### SUBSURFACE WASTEWATER DISPOSAL SYSTEM APPLICATION

Town Or Plantation	Augusta
Street	Route #3
Subdivision Lot #	
<b>PROPERTY OWNERS NAME</b>	
Lee's Trailer Park	
Last:	First:
Applicant Name:	
Mailing Address of Owner/Applicant (if Different)	
R# 7, Box 311 Augusta, Maine 04330

Subject: Replacement Disposal System, Lee's Trailer Park, Augusta.

**DISPOSAL AREA CROSS SECTION**

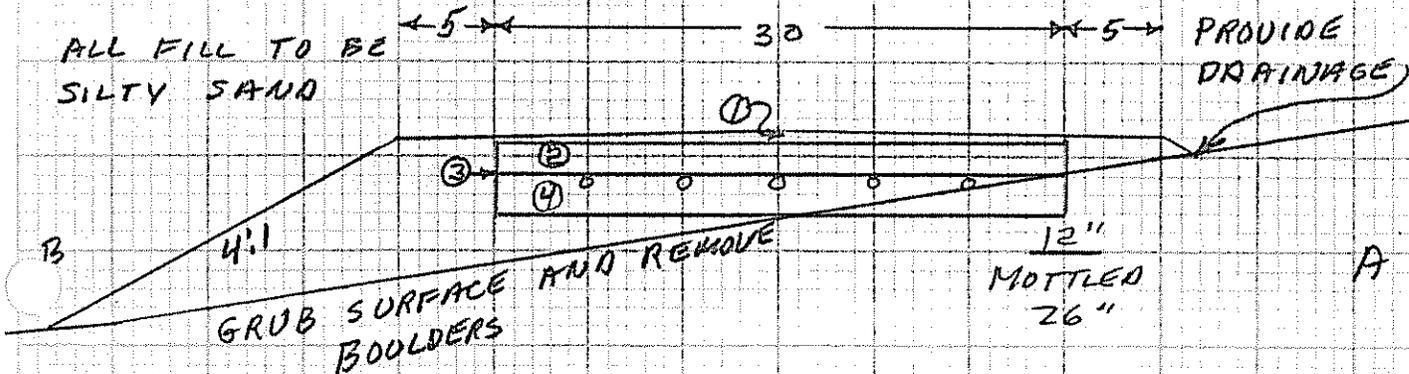
It is the Department's opinion that the stone used in the subject disposal field does not meet the standards of Section 12.B.4 of the Subsurface Wastewater Disposal Rules. The majority of the stone is less than 3/4 inches in diameter and contains a significant amount of soil.

1. Remove the stone and replace it with clean stone greater than 3/4 inches in diameter.
2. Install eight inches of washed stone, greater than 3/4 inches in diameter above the existing stone, raising the distribution lines three inches above the present stone surface.

You should advise Mr. Soucy as to which option you will choose, and you may want to get his approval on a sample of the new stone prior to proceeding.
